Our Case Number: ABP-317780-23

Re: Bray to City Centre Core Bus Corridor Scheme Compulsory Purchase Order 2023
Bray to Dublin City Centre

Re: BRAY TO CITY CENTRE CORE BUS CORRIDOR SCHEME AND COMPULSORY PURCHASE ORDER 2023

Castlethorn and Chartered Land Group Submission on behalf of Aeval Unlimited Company with respect to proposed Permanent and Temporary Acquisition of Lands at Woodbrook, Shankill being Plot Ref. No. 1066(1).1h, 1066(2).2h

FIG 1: Option 1 Layout for Woodbrook entrance

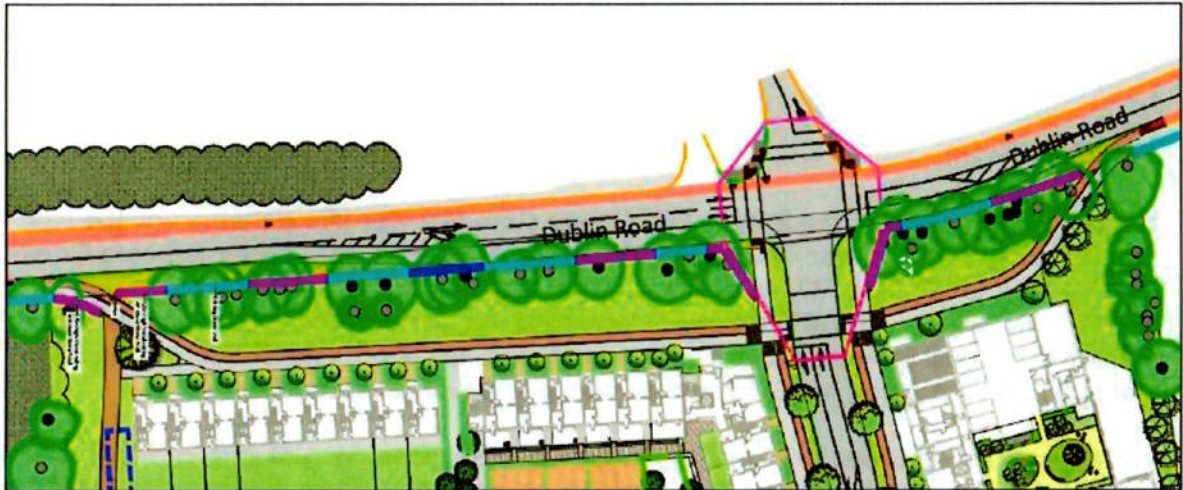
Our proposed entrance arrangement, as detailed in the Site Layout Plan and all supporting architectural, engineering and landscaping drawings was referred to as Option 1 in the Traffic and Transport Assessment prepared by Atkins Consulting Engineers and submitted as part of our SHD application (see Fig 1 below comprising of an extract from the TTA).

FIG 4: Overlay of Permitted Woodbrook Scheme with Proposed Permanent & Temporary Land Acquisition Plans as received from the NTA in March 2023.

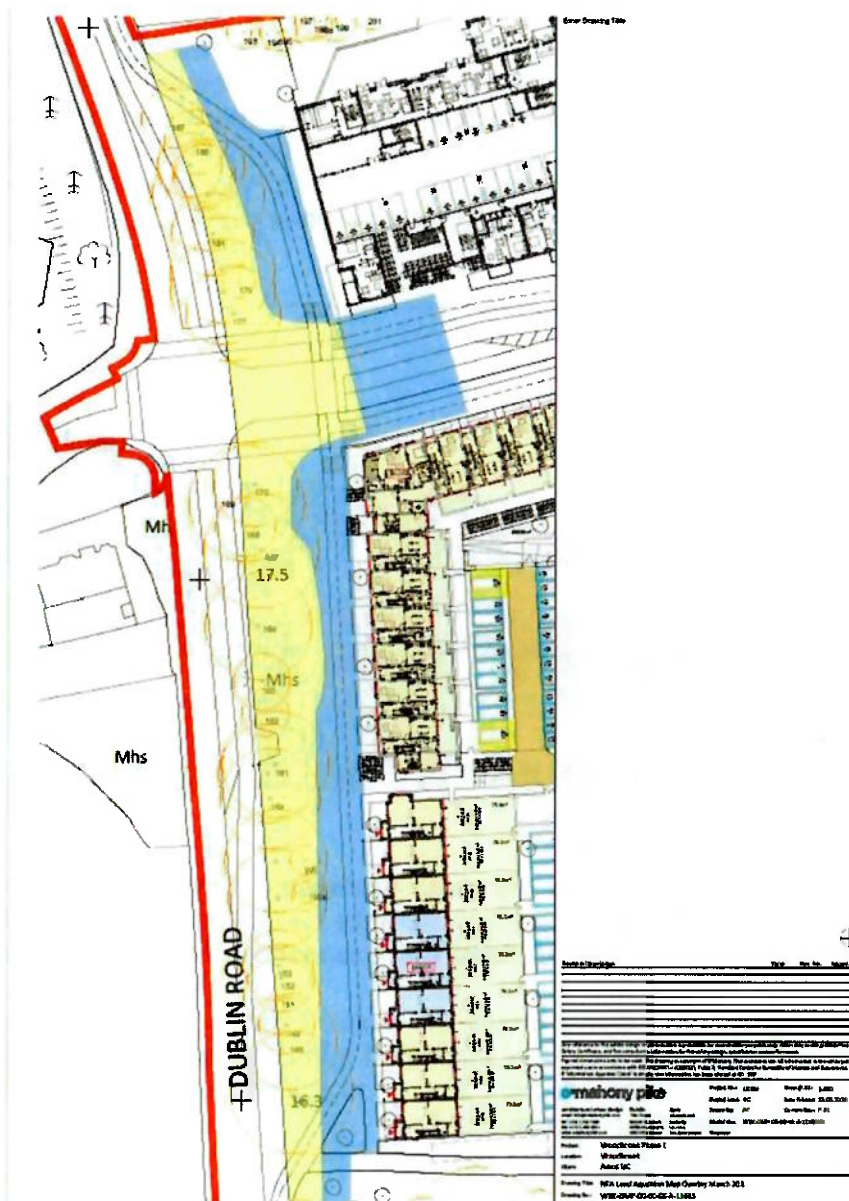
The extent of permanent and temporary land acquisition as indicated in the above plan based on hard copy, coloured plans (beige representing permanent landtake and blue representing temporary landtake) sent to us in March appears consistent with the Compulsory Purchase Order communication and accompanying plans as sent to us on 10th August 2023. We have concerns about the overlap of the proposed temporary acquisition on the footpath and private curtilage of houses and duplexes along that Old Dublin Road frontage and communicated those concerns to the BusConnects project team back in March and we will elaborate on those concerns in the next Section of this submission.

to get to the front door of these dwellings. One can see by reference to Fig 4 above that the blue infill area (extent of proposed temporary land acquisition) extends across the full extent of that existing footpath and adjoining cyclepath, which we submit should be retained and utilised to avoid duplication of pedestrian and southbound cycle facilities along the eastern edge of the expanded Old Dublin Road corridor.

We have concerns as noted with the BusConnects currently proposed design and its potential impact on the established sylvan character and existing entrance at Woodbrook and the residential amenity of those houses and duplexes that front onto the Old Dublin Road. We would respectfully submit that the footpath and southbound cyclepath along the eastern side of the upgraded Old Dublin Road should be retained in any event at that existing, recently constructed new alignment along the front of the Woodbrook site thereby reducing the continuous corridor width of the widened Old Dublin Road and avoiding the duplication of such pedestrian and cycle facilities so close to these permitted facilities as constructed on-site. The eastern extent of the BusConnects widened corridor, if dedicated bus lanes at this location are deemed essential, would thus be the southbound bus lane and bus stop with a pathway connection east from the bus stop to the adjacent footpath and cyclepath as existing at Woodbrook.

FIG 5: Extract from Landscaping Design Sheet 48 of 54

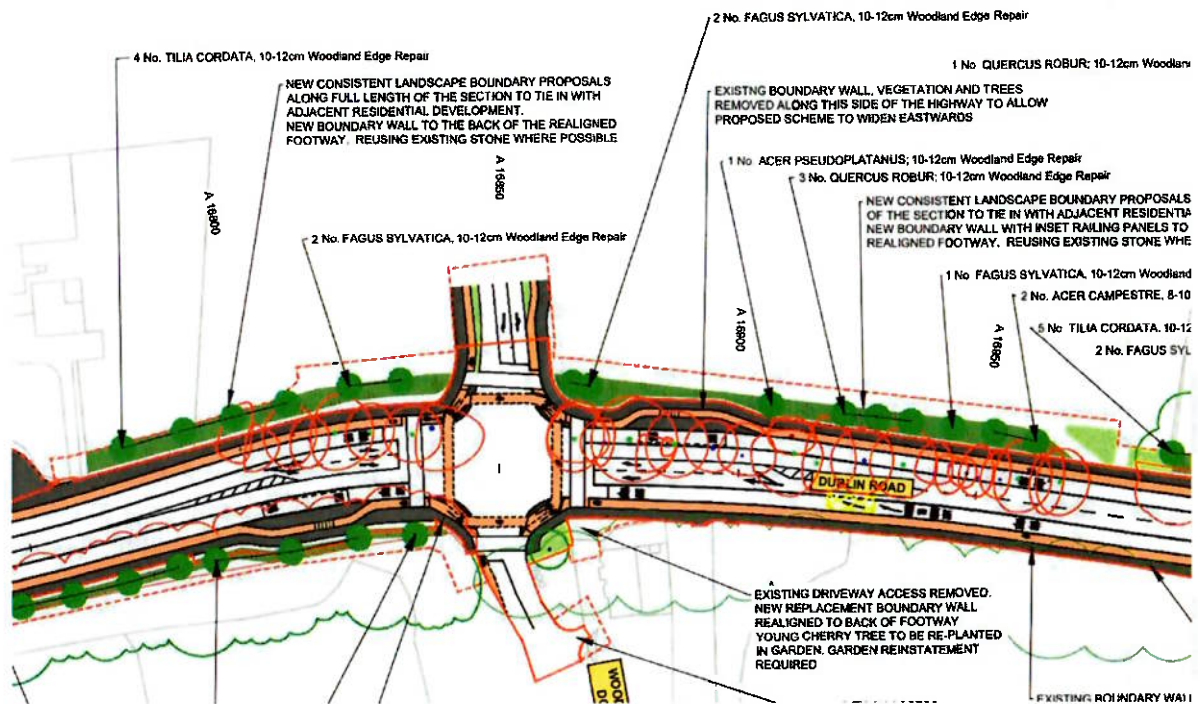
We are not reassured by the indicative hedge planting and intermittent tree planting suggested in that proposed Landscaping Plan and would respectfully request a widened 'green corridor' to serve as a more significant landscape buffer and a more intensively planted row of native new semi-mature trees of more significant girth to compensate for the very significant impact that the BusConnects works could have on the character and residential amenity of Woodbrook and on the otherwise continuous sylvan character of the Old Dublin Road.
